# Service Bulletin

Bulletin No.: 21-NA-142

**Subject: Front Brake Grind/Groan Noise After Sitting Overnight**

**This bulletin replaces PIT5805B. Please discard PIT5805B.**

5743643

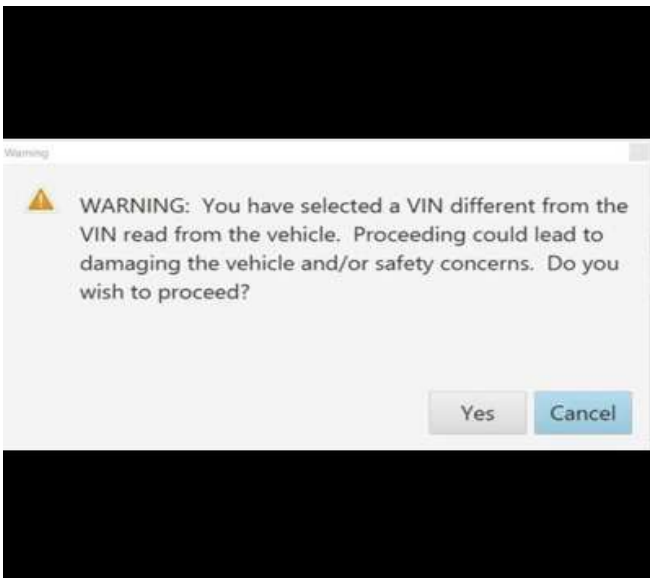
**Caution:** Be sure the VIN selected in the drop down menu (1) is the same as the vehicle connected (2) before beginning programming.

5644478

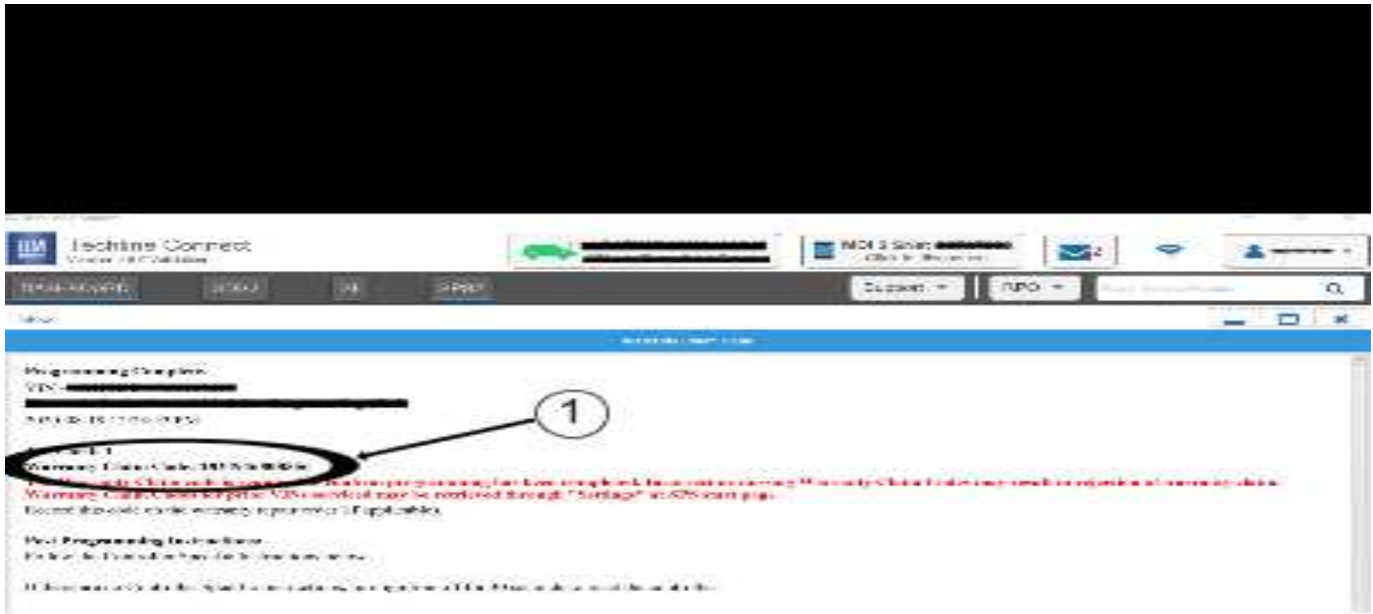
**Important:** To avoid warranty transaction rejections, you **MUST** record the warranty claim code provided on the Warranty Claim Code (WCC) screen shown above on the job card. Refer to callout 1 above for the location of the WCC on the screen.

2. Record SPS Warranty Claim Code on job card for warranty transaction submission.
